Access Compliance Report

Public Rights-of-Way

(Curb Ramps)

Intersection ID: 12517	Main Street: N_SHARON_AMITY_RD	Cross Street: SHAMROCK_DR	Location: N
ADA ID: 0944F323D893	Ramp Type: Perp	Initial Pass/Fail: Fail	Overall Compliance: No
			Severity Score: 13.75

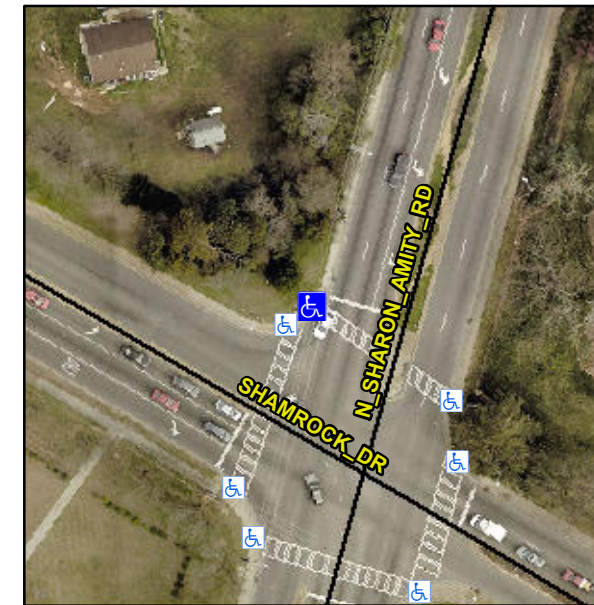
Not Found, R304.2.2, R304.5.3

Compliance	Description	Data	Compliance	Description	Data
N/A	Ramp Length (in)	60.0	No	Ramp Slope (%)	10.3
Yes	Ramp Width (in)	48.0	No	Ramp XSlope (%)	4.0
N/A	Flare Type LT	N/A	N/A	Flare Type RT	N/A
N/A	Flare Slope LT (%)	N/A	N/A	Flare Slope RT (%)	N/A
N/A	Flare Traversable LT?	N/A	N/A	Flare Traversable RT?	N/A
N/A	Landing Length (in)	N/A	N/A	DWS Provided?	N/A
N/A	Landing Width (in)	N/A	N/A	DWS Contrast?	N/A
N/A	Landing Slope (%)	N/A	N/A	DWS Length (in)	N/A
N/A	Landing X Slope (%)	N/A	N/A	DWS Full Width?	N/A
N/A	Landing Curb? (Y/N)	N/A	N/A	DWS Offset (in)	N/A
N/A	Shared Landing?	N/A			
N/A	Gutter Ponding?	N/A	N/A	Gutter Slope (%)	N/A
N/A	Gutter Lip Ht (in)	N/A	N/A	Gutter X Slope (%)	N/A
N/A	Painted X Walk1?	Yes	N/A	Painted X Walk2?	N/A
	X Walk 1 Direction	To SE		X Walk 2 Direction	N/A
N/A	X Walk 1 Width (in)	82.0	N/A	X Walk 2 Width (in)	N/A
	X Walk 1 Slope (%)	2.0		X Walk 2 Slope (%)	N/A
	X Walk 1 X Slope (%)	0.9		X Walk 2 X Slope (%)	N/A

Remove & Replace Entire Ramp.
